Access Compliance Report

Public Rights-of-Way

(Curb Ramps)

Intersection ID: 45133	Main Street: SATTERFIELD_CT	Cross Street: LITTLE_WHITEOAK_RD	Location: NE
ADA ID: 2126B32CD031	Ramp Type: PerpDiag	Initial Pass/Fail: Fail	Overall Compliance: No
Severity Score: 8.75			
Codes/Mitigation Info/Possible Solution		Field Measurements/Component Compliance

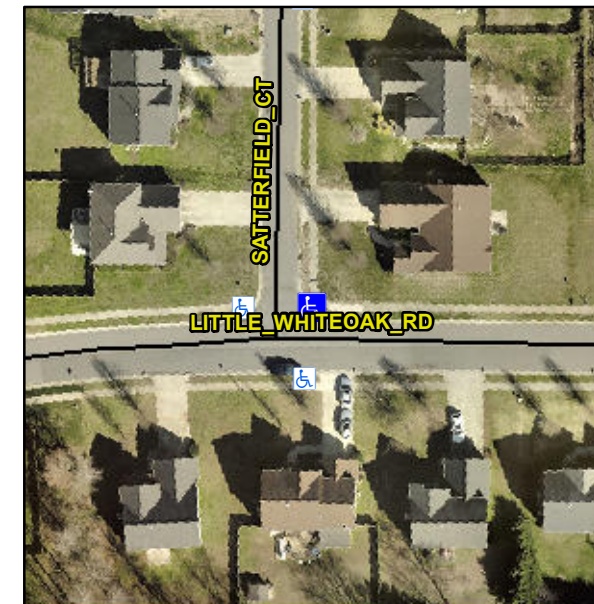
Not Found, R304.5.1

Compliance	Description	Data	Compliance	Description	Data
N/A	Ramp Length (in)	49.0	Yes	Ramp Slope (%)	7.8
No	Ramp Width (in)	45.0	Yes	Ramp XSlope (%)	0.3
N/A	Flare Type LT	N/A	N/A	Flare Type RT	N/A
N/A	Flare Slope LT (%)	N/A	N/A	Flare Slope RT (%)	N/A
N/A	Flare Traversable LT?	N/A	N/A	Flare Traversable RT?	N/A
N/A	Landing Length (in)	N/A	N/A	DWS Provided?	N/A
N/A	Landing Width (in)	N/A	N/A	DWS Contrast?	N/A
N/A	Landing Slope (%)	N/A	N/A	DWS Length (in)	N/A
N/A	Landing X Slope (%)	N/A	N/A	DWS Full Width?	N/A
N/A	Landing Curb? (Y/N)	N/A	N/A	DWS Offset (in)	N/A
N/A	Shared Landing?	N/A			
N/A	Gutter Ponding?	N/A	N/A	Gutter Slope (%)	N/A
N/A	Gutter Lip Ht (in)	N/A	N/A	Gutter X Slope (%)	N/A
N/A	Painted X Walk1?	No	N/A	Painted X Walk2?	No
	X Walk 1 Direction	To W		X Walk 2 Direction	To S
N/A	X Walk 1 Width (in)	N/A	N/A	X Walk 2 Width (in)	N/A
	X Walk 1 Slope (%)	1.7		X Walk 2 Slope (%)	2.8
	X Walk 1 X Slope (%)	2.2		X Walk 2 X Slope (%)	2.8

N/A	Ramp inside XWalk1?	N/A	N/A	Ramp inside XWalk2?	N/A
	Road Slope (%)	0.9	N/A	Clear Space?	N/A
	Road X Slope (%)	4.8	N/A	Clear Space to XWalk (in)	N/A
N/A	Any Obstructions?	N/A	N/A	Storm Grate/Utility Hazard?	N/A
	Obstruction Type			Storm Grate/Utility Type	
		N/A			N/A
			Yes	Surface Condition? (G/P)	Good

Remove & Replace Curb Ramp With Two New Directional Ramps or Equivalent.
